BEN LOMAND MOUNTAIN VILLAGE

LANDSCAPE SITE PLAN

Landscape Plans

El Paso County, Colorado

LANDSCAPE PLAN

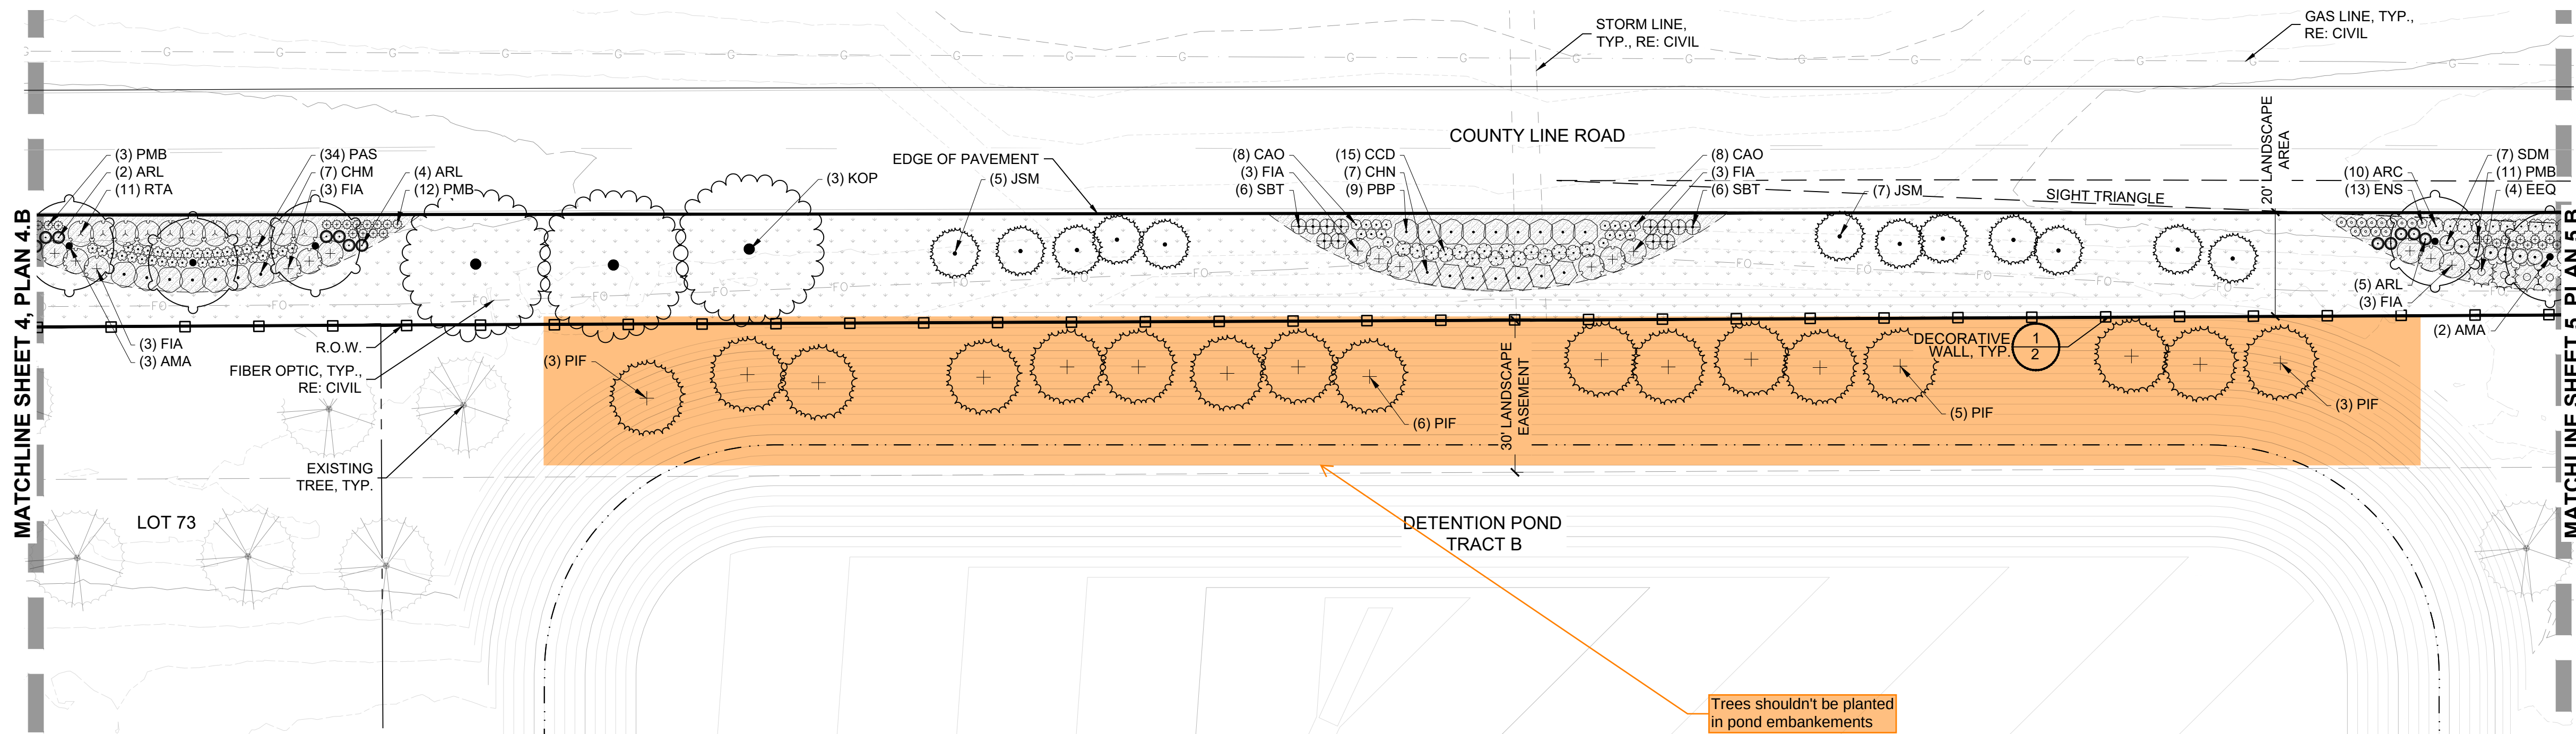
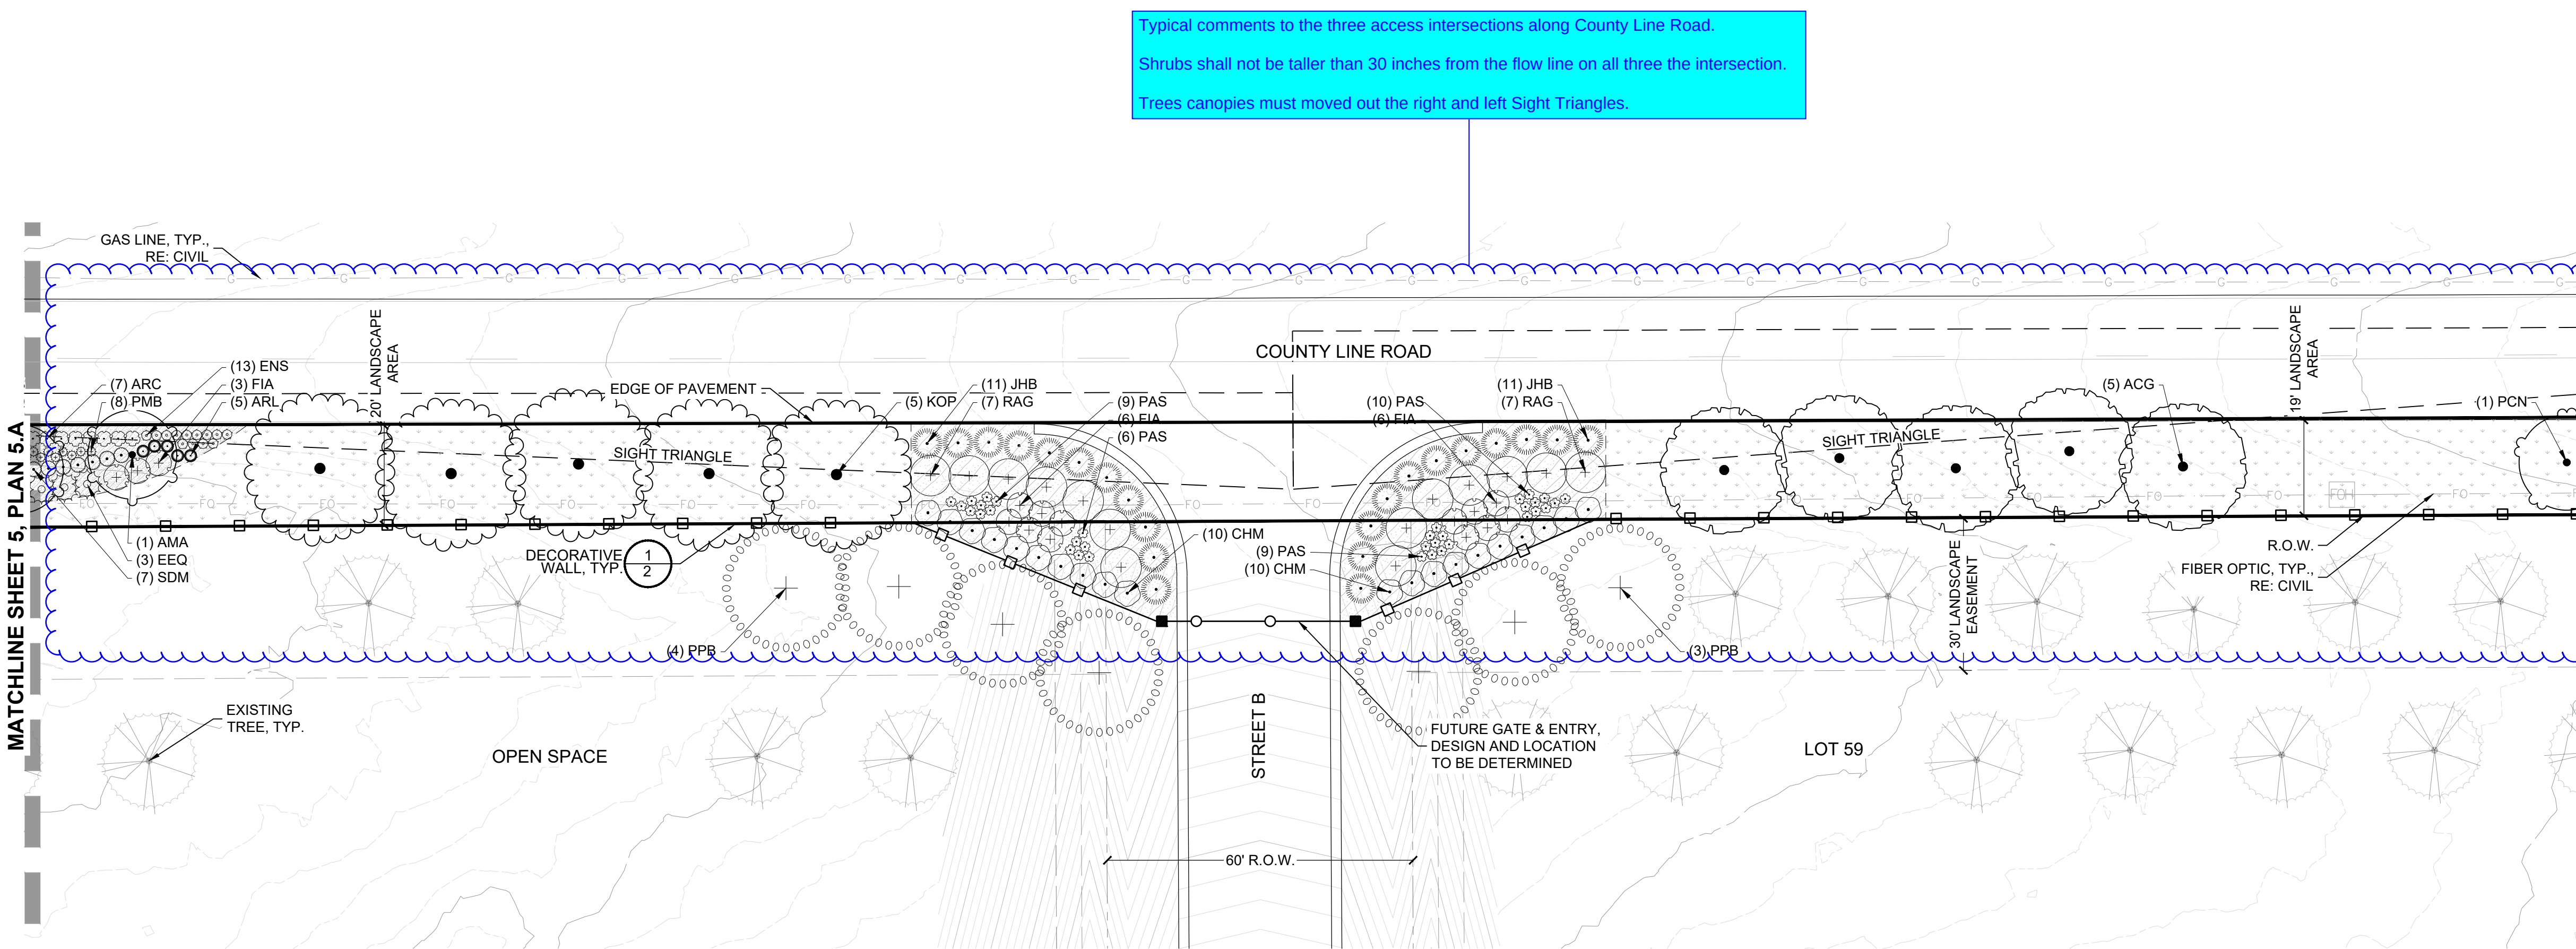
Typical comments to the three access intersections along County Line Road.
Shrubs shall not be taller than 30 inches from the flow line on all three the intersection.
Trees canopies must moved out the right and left Sight Triangles.
